Bridge Replacement SR 43/US 378 at Savannah River

Project Number: BR000-0001-00(370)

Value Engineering Study Report

90% Design Complete Stage

ALT. NO. BD-1

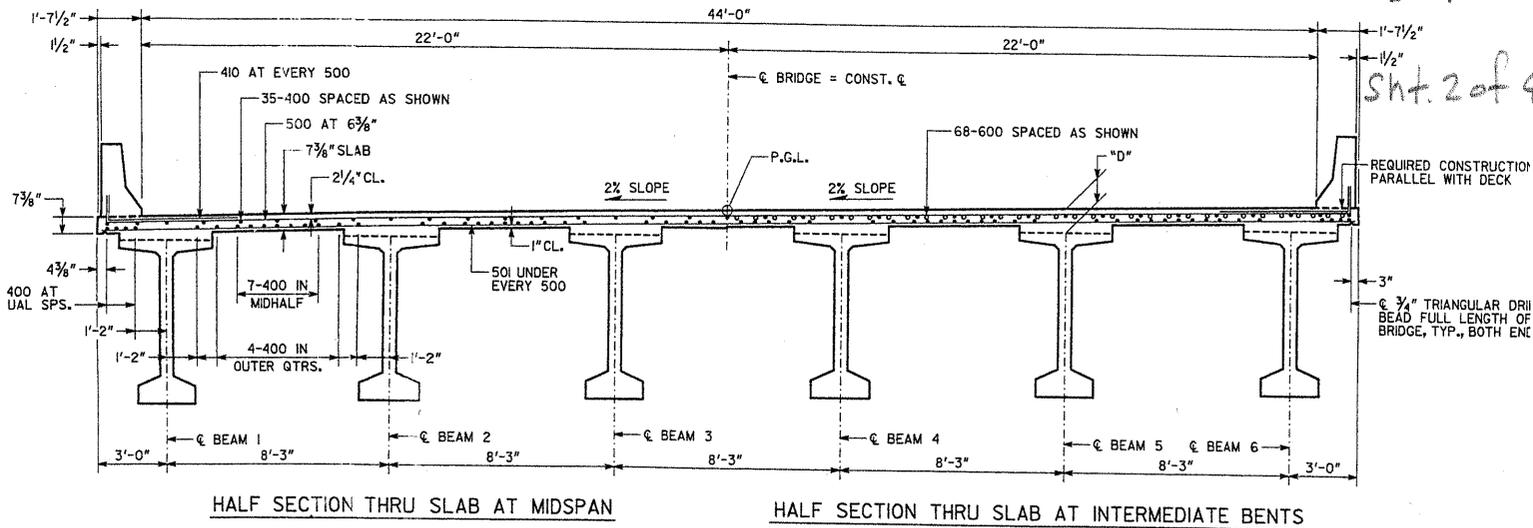
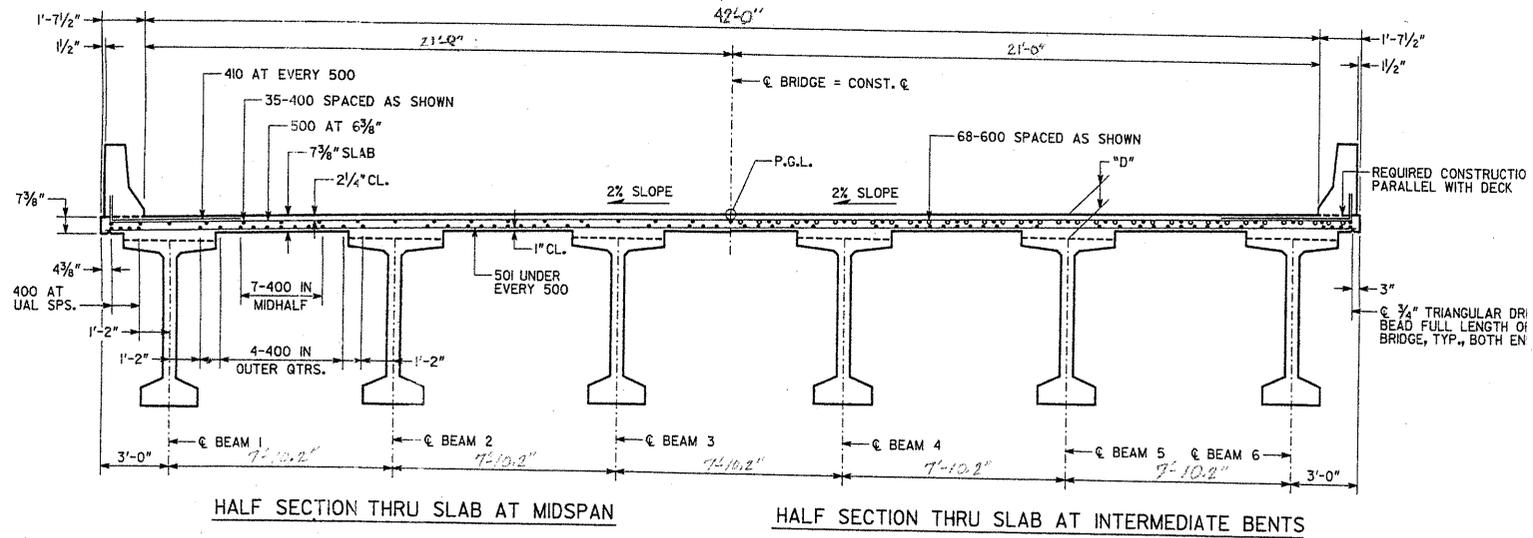
DESCRIPTION: **ON BRIDGE DECK USE 11-FT-WIDE LANES IN LIEU OF
 12-FT-WIDE LANES**

The proposed section includes two 12-ft-wide travel lanes with 10 ft rural shoulders, 2 ft of which are paved in the roadway portion. The total bridge width is 44 ft, which includes two 12-ft-wide travel lanes and also has two 10 ft shoulders.

The travel lanes through the projects limits could each be reduced by 1 ft.

The lanes can be reduced by 1 ft each because it will save on costs. Additionally, the vehicles per day (vpd) counts are small and prove that the volumes are not high at any given time. Lastly, although the truck percentage is significant by retaining the 10 ft shoulders, this should ease the concern of side-swiping if there is one.

DESCRIPTION: **REDUCE THE SHOULDER WIDTH FROM 10 FT TO 8 FT,
 NARROW THE BRIDGE DECK AND ELIMINATE ONE
 BRIDGE GIRDER** SHEET NO.: **1 of 6**

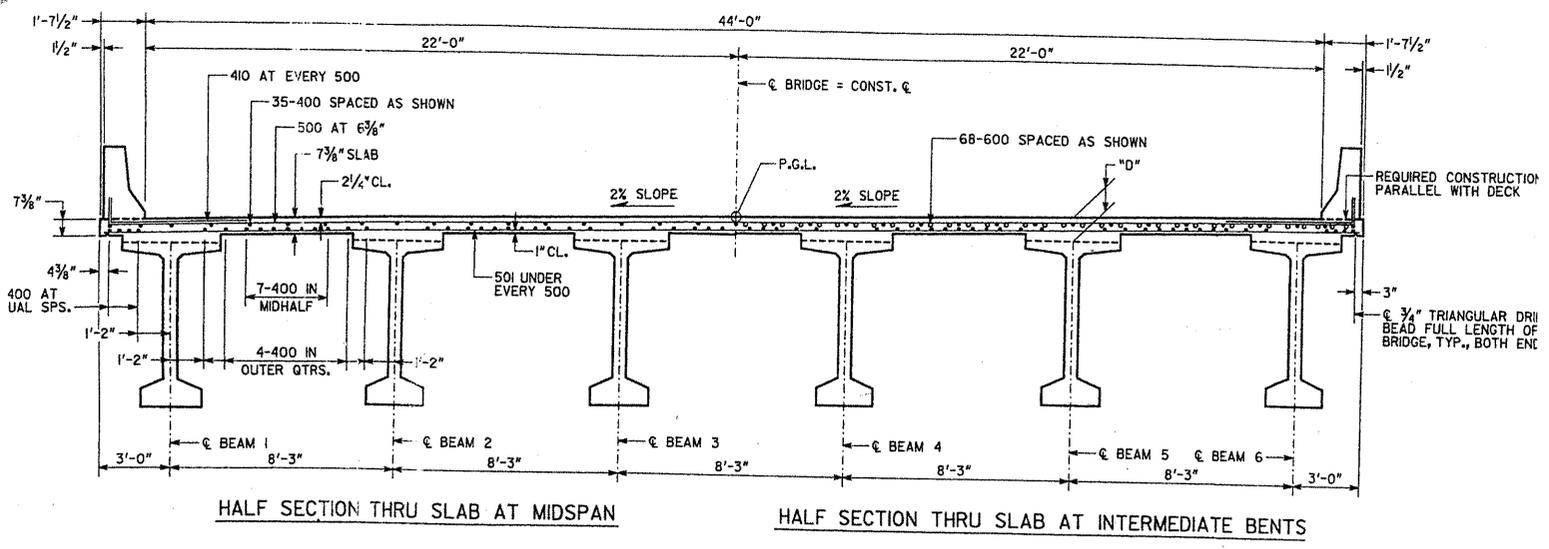
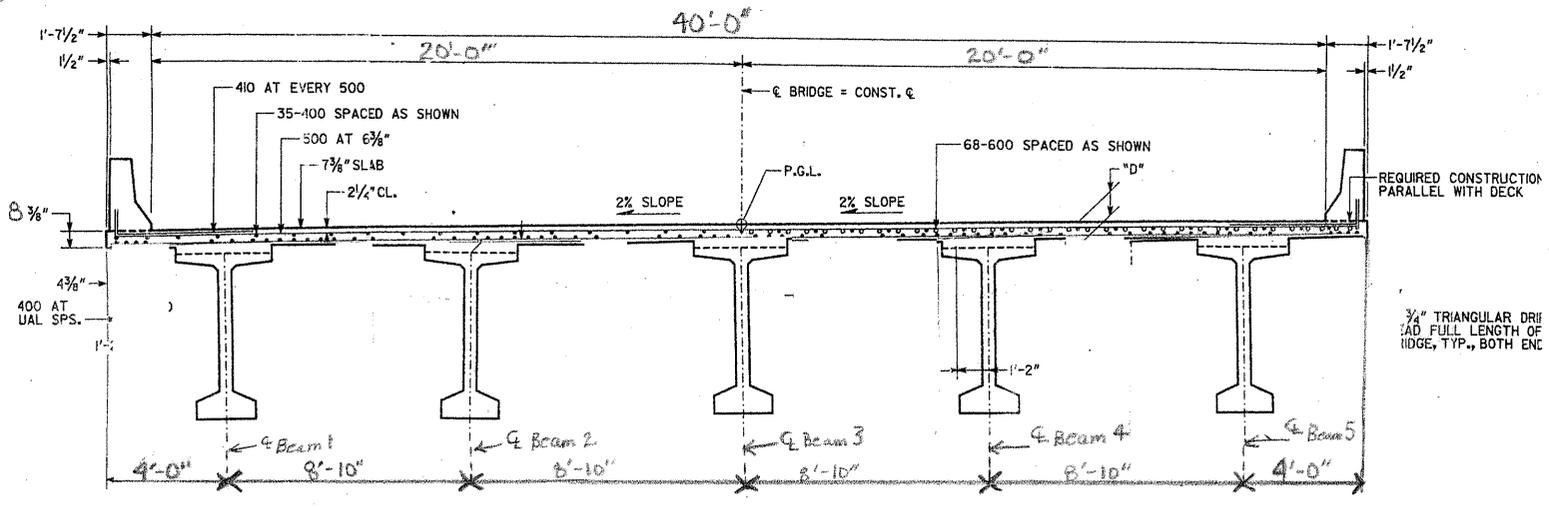
The proposed design includes two 10-ft-wide shoulders along the bridge deck and in the roadway portion.

Instead of designing 10-ft-wide shoulders, use 8-ft-wide shoulders along the deck as well as the roadway. By doing this, only five of the six beams is needed.

By reducing the 10 ft shoulder width to 8 ft, this allows for the elimination of a beam as well. This results in cost savings of asphalt, concrete and an entire beam. The span widths will have to be adjusted accordingly.

The GDOT policies and procedures recommend this.

ALTERNATIVE NO.: **BF-1**

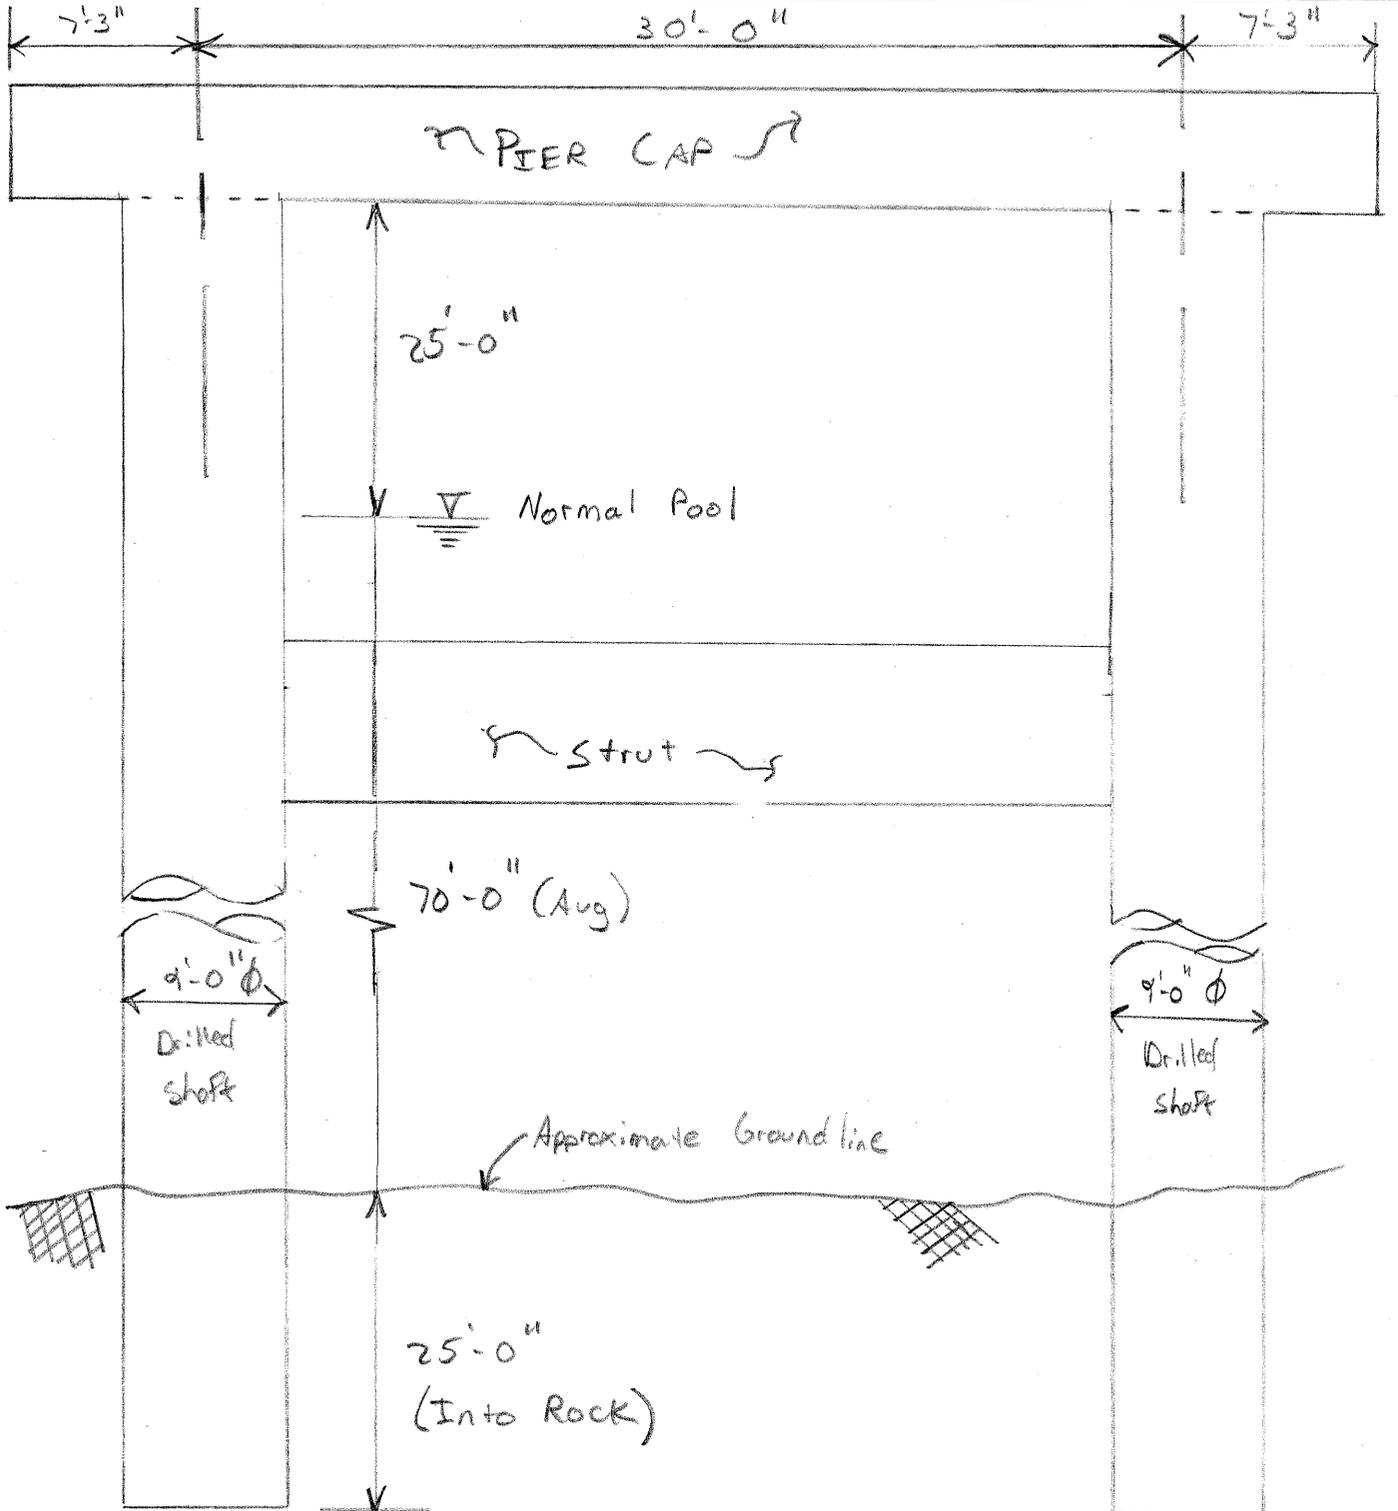
The original design has 11 hammer head piers on spread footings in deep water (70 ft). A coffer dam with a 25-ft-thick concrete seal will have to be constructed at each pier to erect the pier.

Replace the hammer head piers on spread footings with a two-column drilled shaft pier.

Drilled shafts will eliminate the large footing and the costly coffer dam. Construction time will decrease with the drilled shaft construction because the contractor will not need to assemble the coffer dam and dewater. Based on a bridge in Florida, it appears that 9-ft-diameter shafts with a strut at about mid-height will be sufficient to carry the loads, making it a very economical solution. An option would be to allow the contractor to submit an alternate design for the foundation during the bid period.

An option would be to allow the contractor to submit an alternate design for the foundation during the bid period.

ALTERNATIVE NO.: *BF-7*

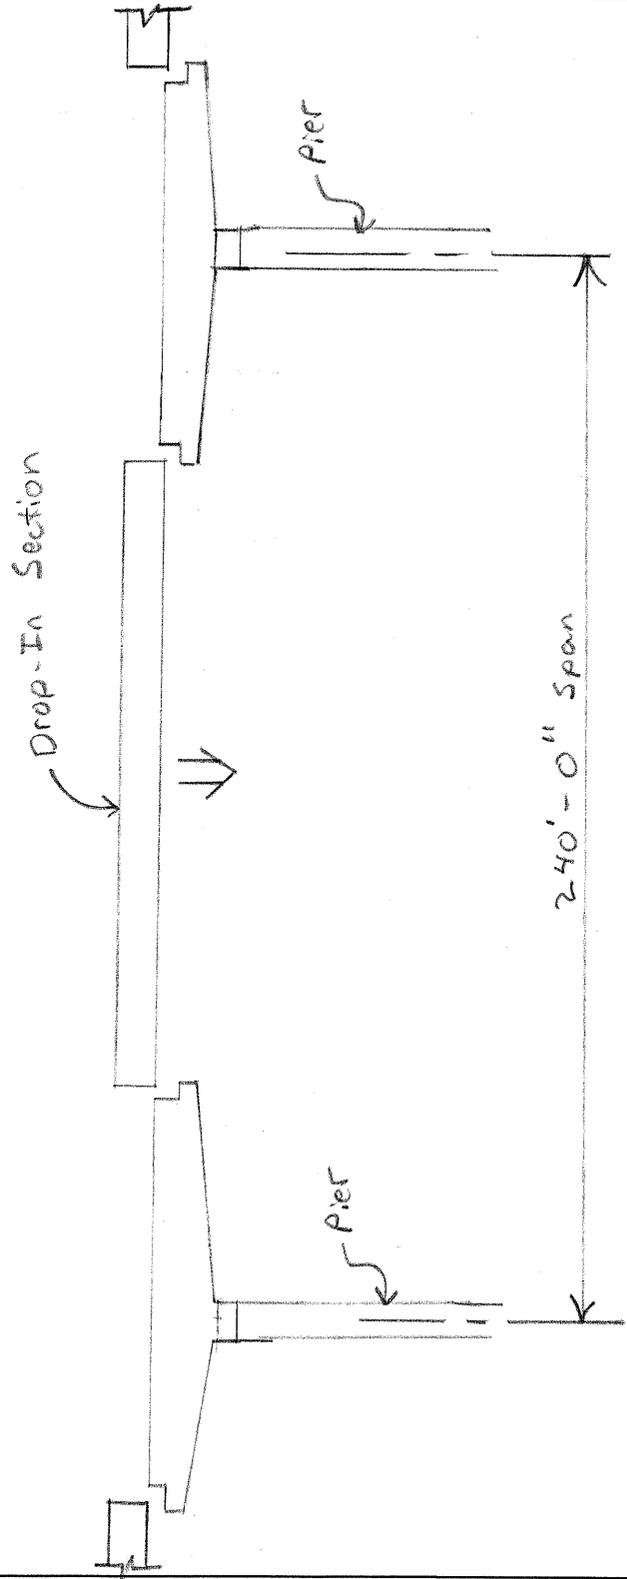
The original design uses 12 ft spans at 140 ft spacing for a total bridge length of 1,680 ft. The bridge deck is supported on 6 74-in-deep precast concrete bulb tee sections.

Use seven approximately 240 ft spans for a total bridge length of 1,680 ft. Use give post-tensioned concrete girders with a drop-in section to support the bridge deck over the 240 ft spans.

The long-span post-tensioned concrete girders will eliminate five piers and coffer dams and decrease the construction time, thus saving costs. This is a common construction method used in states bordering Georgia.

*- Set drop-in section and post-tension each girder
in 3 or 4 span sections to achieve the 240'-0" spans.*

ALTERNATIVE NO.: *E-2*

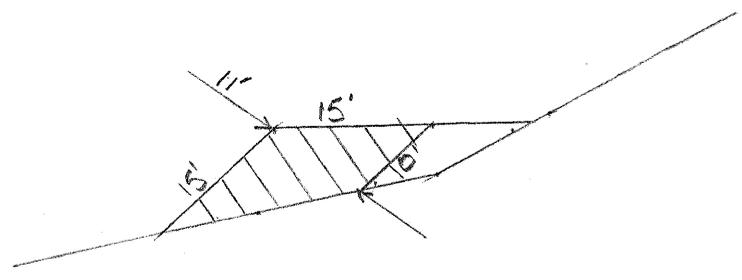
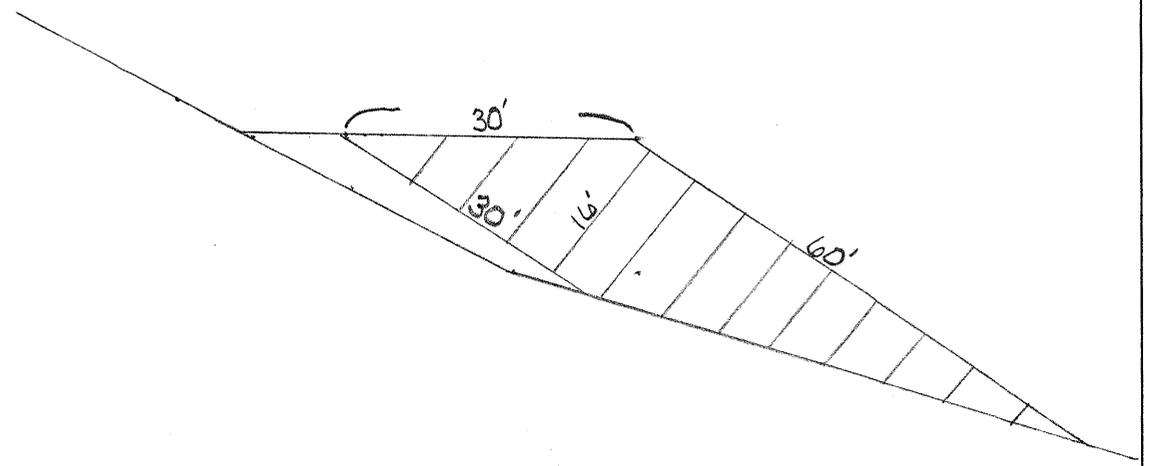
Rock embankment extends approximately 40 ft beyond the riprap slope at the abutments.

Reduce the extent beyond the riprap to 10 ft.

Reduce the limits of rock embankment beyond the riprap slope at both abutments. This will reduce the overall cost of the project.
